City of Dublin

Memo

Re: Ordinance 03-16 – Rezoning approximately 30 acres, located on the east side of Perimeter Loop Drive, north of US 33/SR 161, south of Perimeter Drive and Venture Drive from PUD, Planned Unit Development District (existing MAG plan) and PCD, Planned Commerce District (Perimeter Center, Subarea D) to PUD (Midwestern Auto Group PUD) to incorporate approximately 5.4 acres into the MAG PUD to expand the automobile dealership campus to accommodate the construction of a combined showroom for the Jaguar and Land Rover brands, the future demolition of the existing Land Rover showroom, a new showroom for the Porsche brand, and the addition of an elevated showroom addition to the main building for the Lamborghini brand. (Case 15-113Z/PDP)

PROJECT NUMBER: **A15-046**
 SHEET TITLE: **MASTER SIGN PLAN**
 SHEET NUMBER: **1.03**

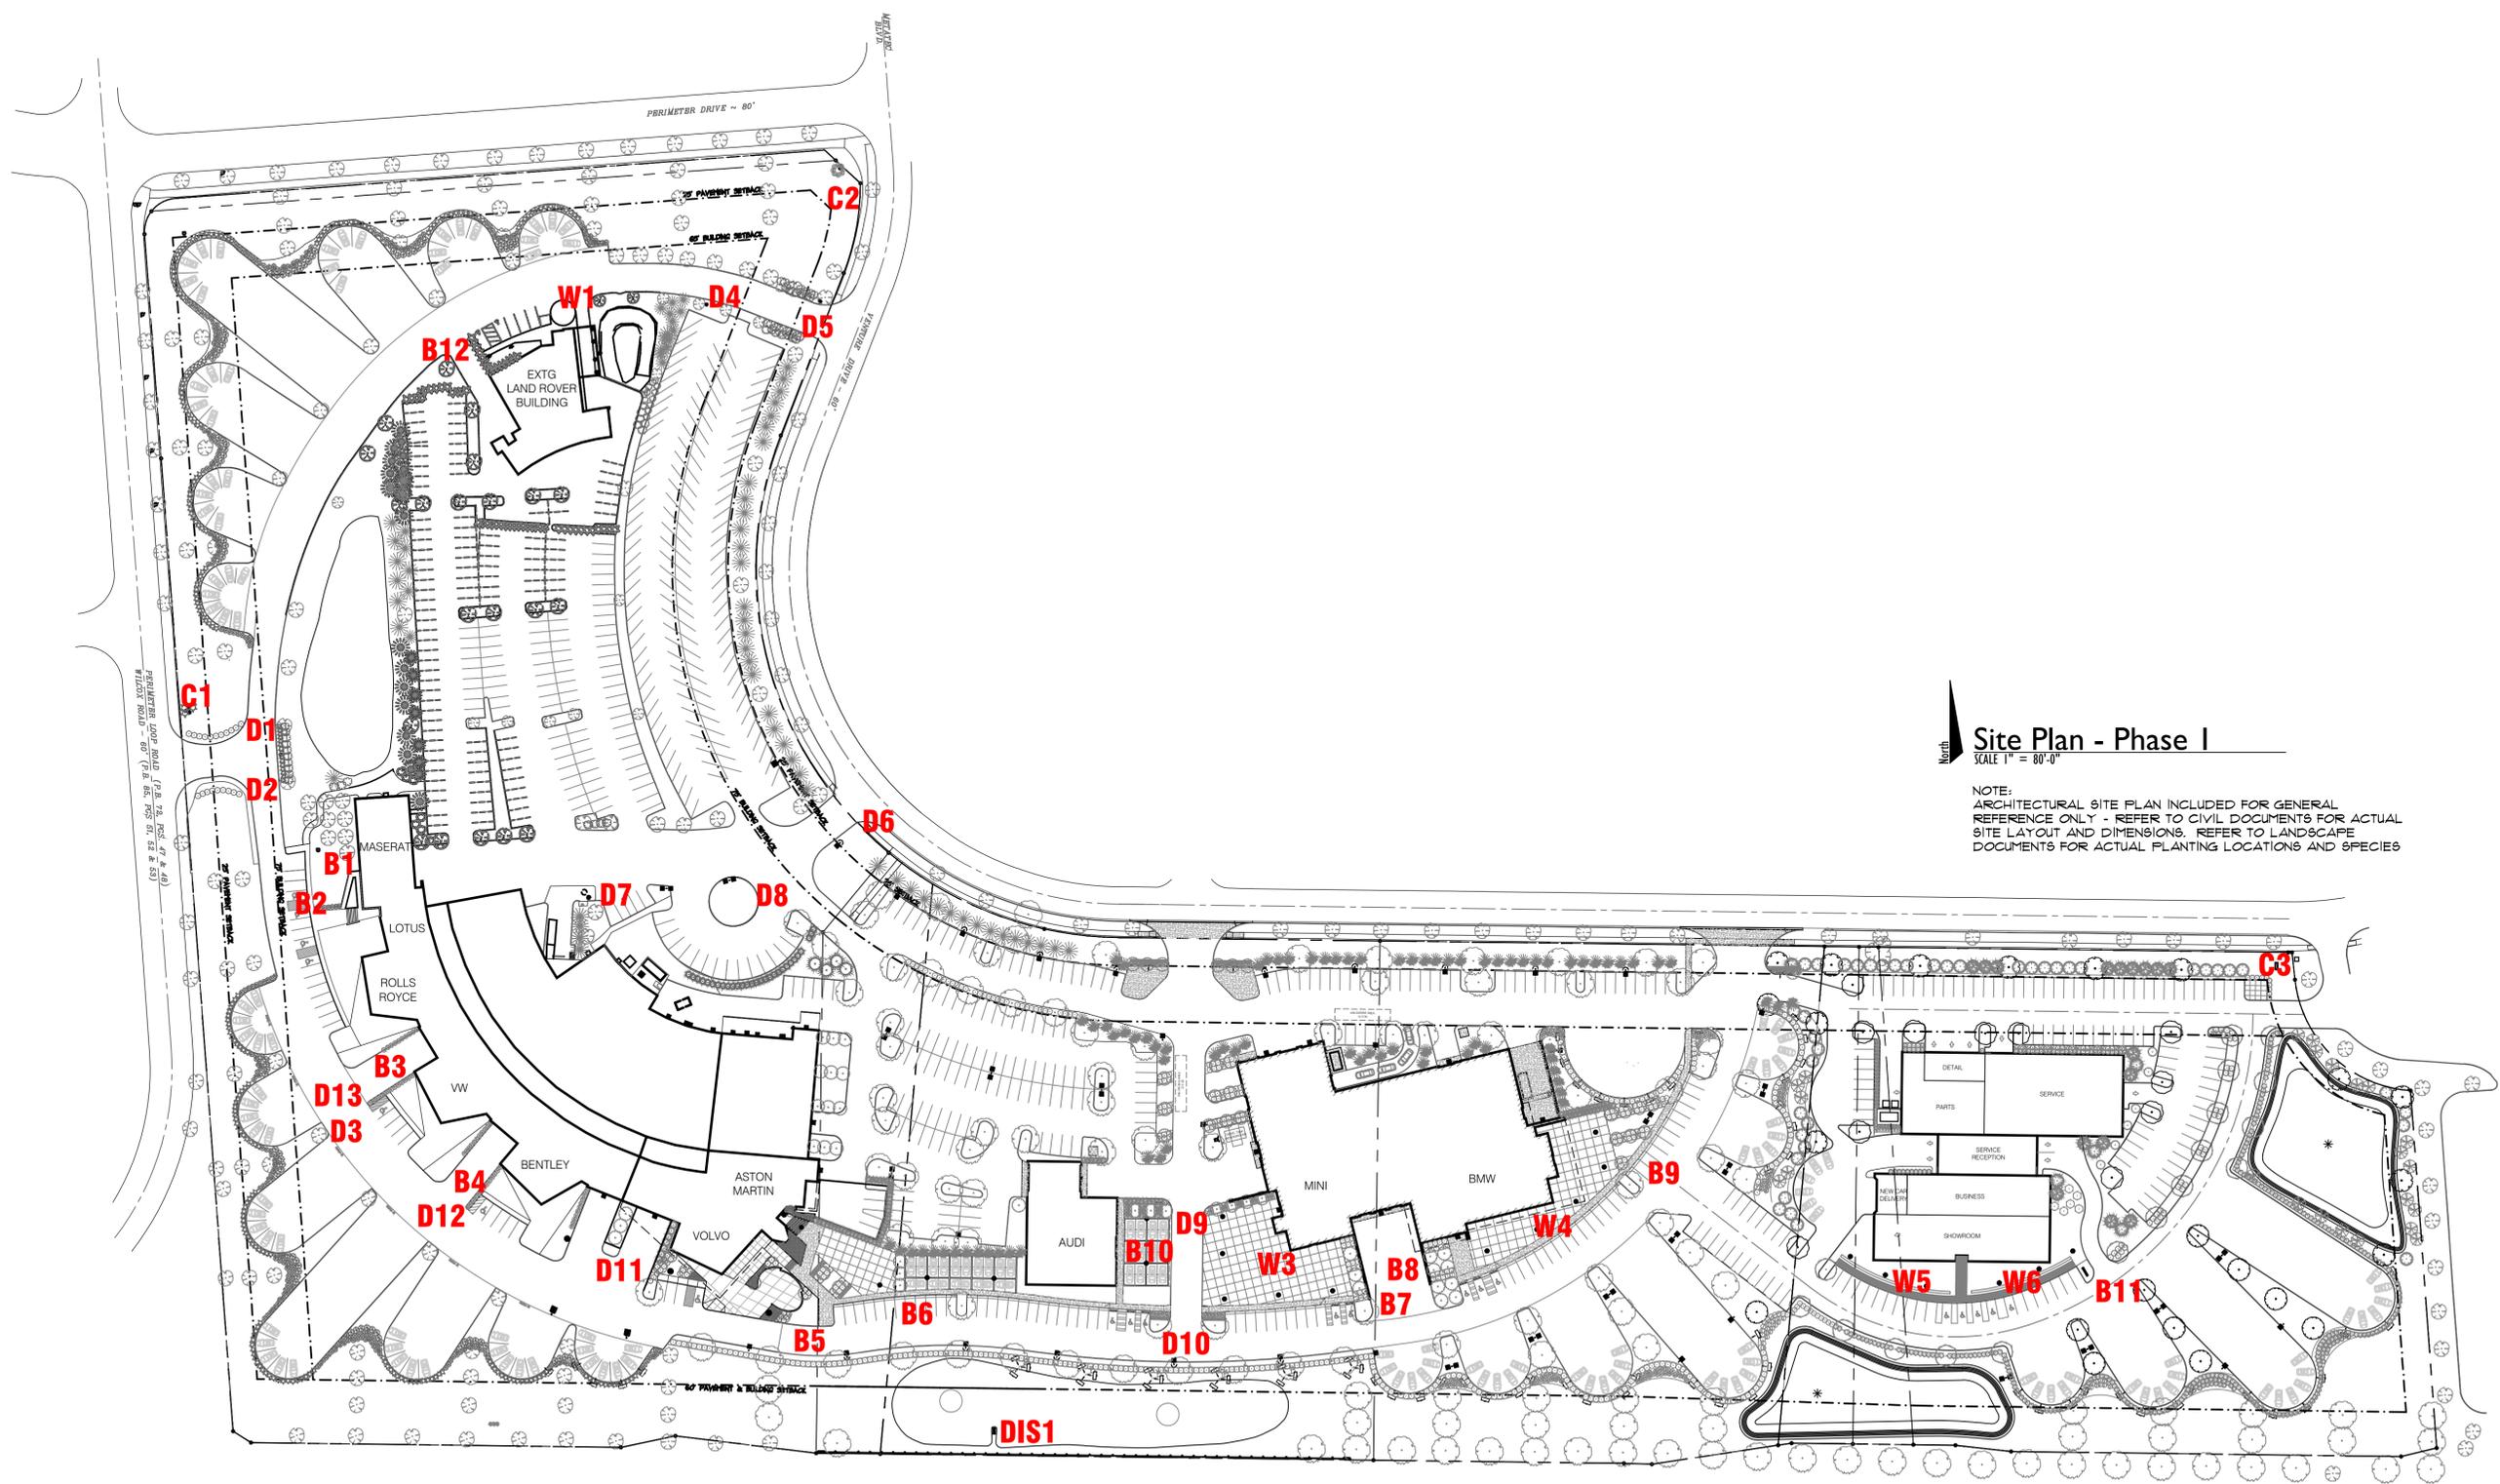
- **Directional:** These signs are permitted throughout the site and provide wayfinding to the various sales and services areas internal to the site. The text permits directional ground signs at a maximum height of 55 inches and a maximum width of 42 inches. One sign in the inventory appears to not meet these standards and should be revised (Sign D2).

The proposed signs in Subarea C are higher than what Code permits and what the Commission approved for the adjacent Subarea. The total combined sign size of 100 square feet will potentially permit a single sign to exceed 50 square feet (the Land Rover sign is shown at 53 square feet, while Jaguar is shown at 41 square feet). Given the height of the proposed showrooms and the 74 feet of length of each, which would allow a 74-square-foot sign (but not one for each brand), the proposed sign language in the text and the details in the preliminary development plan are appropriate. The proposed sign height is 20 feet according to the applicant.

- 13) That the applicant revise Sign D2 to meet the development text requirements.

SHEET TITLE: JAGUAR LAND ROVER ELEVATIONS

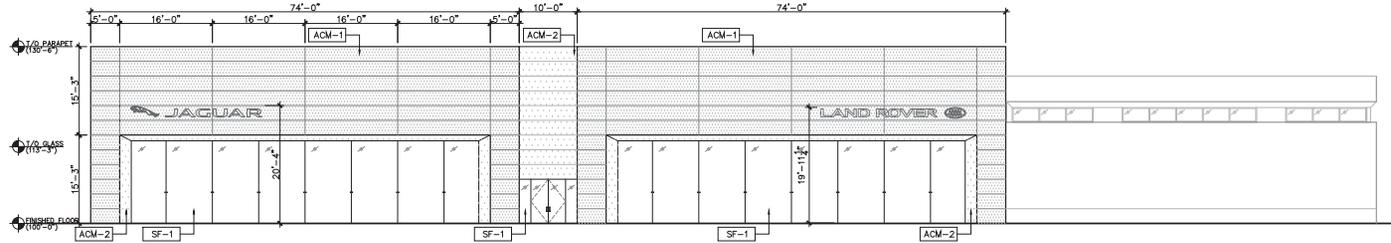
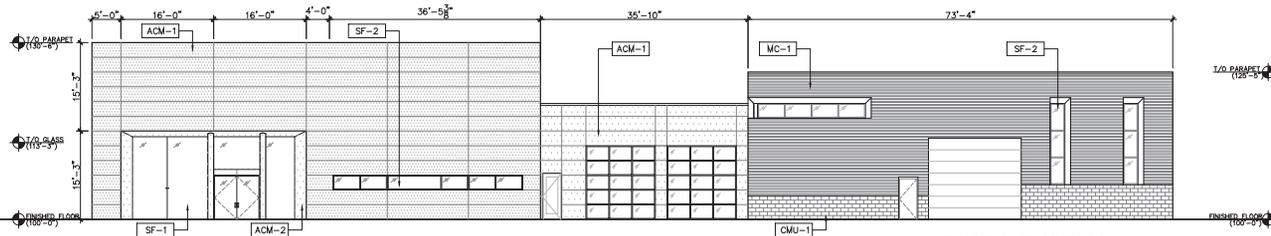
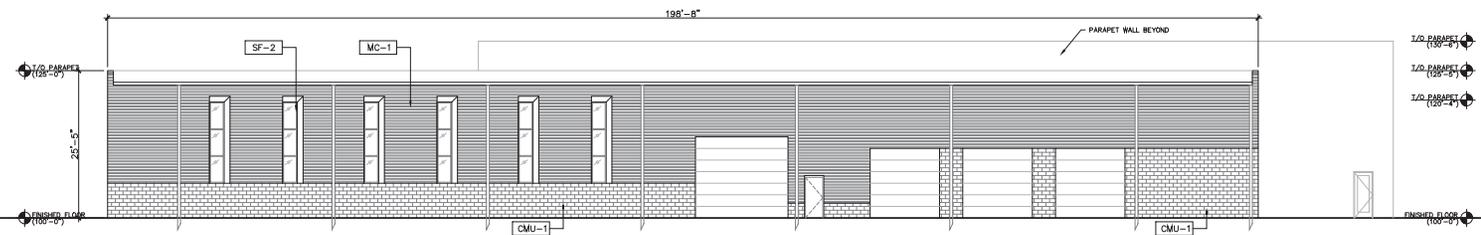
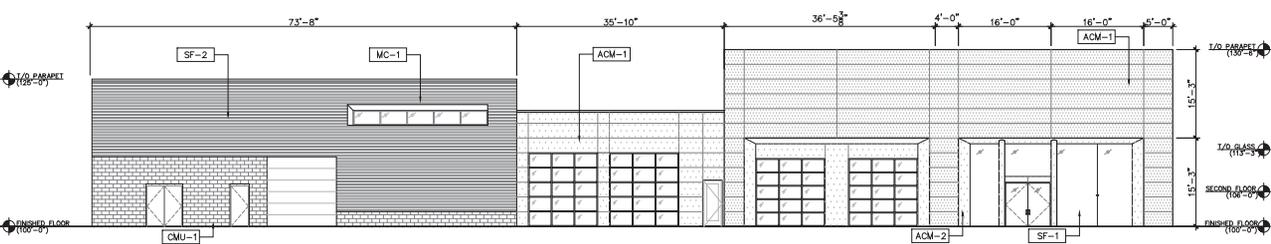
The remaining elevations include CMU, metal and metal cladding as building materials. The changes in materials, use of windows and recesses in the elevations create interesting viewpoints and continue the contemporary look of the campus. The plans show the use of EIFS in the legends but not on the actual elevations.

- 1) That the plans be revised to address building material inconsistencies on sheet 4.01;
